RCSL: 44 - RT 1911

<b>SERIAL EFFECTIVITY</b> All keyboards produced after september th 1st 1981	<b>EQUIPMENT AFFECTED</b> <u>Key-tronic keyboards</u> RC721, RC722, RC801, RC802, RC803, RC805 keyboards.
<b>NOTE</b>

# FIELD CHANGE ORDER

Modification to  
RC 721 / RC 722 Keyboard  
and RC 850

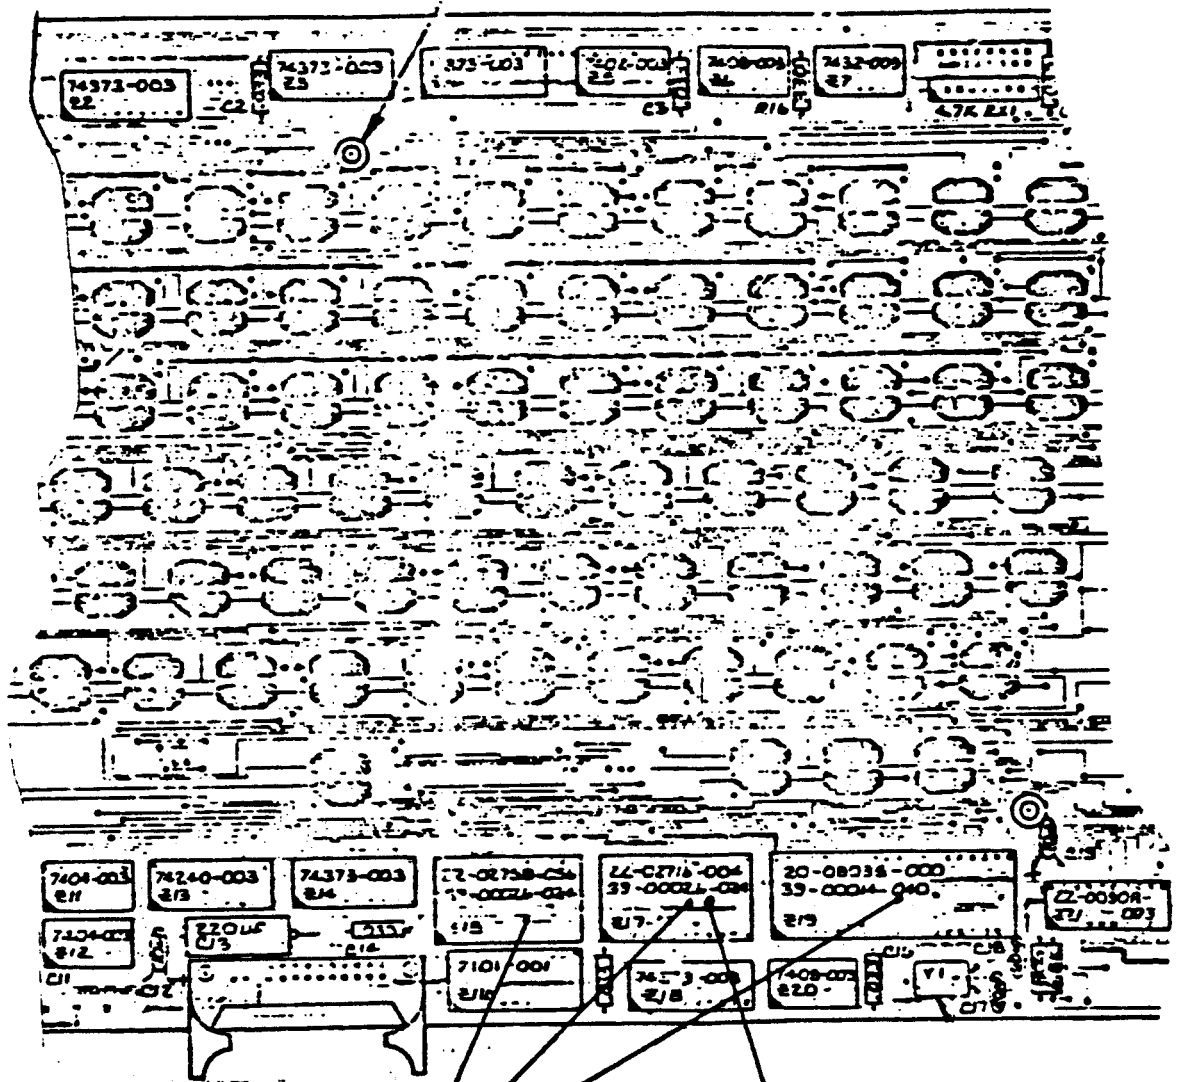
The sockets for the CPU, the program ROM and the external ASCII ROM has too low contact pressure and too poor contact surface.  
The keyboard may fail after an interval of 1 to 12 months. The manufacturer of the sockets is "SCANBE",

1. Change the 3 sockets to those supplied with the FCO-Kit. See next page.
2. Change the program PROM to a KTC-013. The old PROM must be returned.
3. Code the FCO-label: 19-006.

Insert 3 new sockets

Change EPROM to new version: KTC 013
